PCN – Product Change Notification

PCN-A-080522

ECN Topic: New 8.4 inches IP65 Dimension is integrated into Winmate's Panel PCs

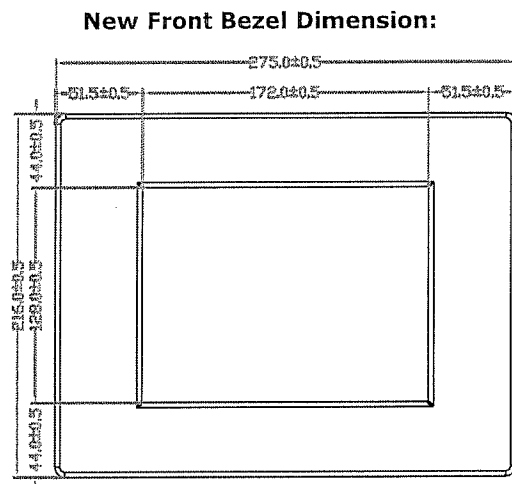
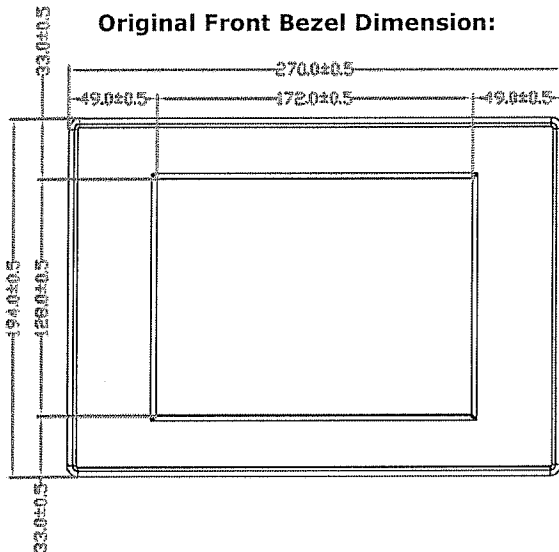
To upgrade Winmate's 8.4 inches Panel PCs, we would like to inform you that about our Product changes on the IP65 Front Bezel and Cut Out Dimension.

We will use a new 8.4 inches IP65 Front Bezel and Cut Out dimension for T series/T5 series/S series Panel PC. The dimension of Front Bezel will change to 275 x 216 mm from 270 x 194 mm and the Cut Out Dimension will change to 251.4 x 180 mm from 250.4 x 177.6 mm. The rest of the housing dimension will be the same to original ones.
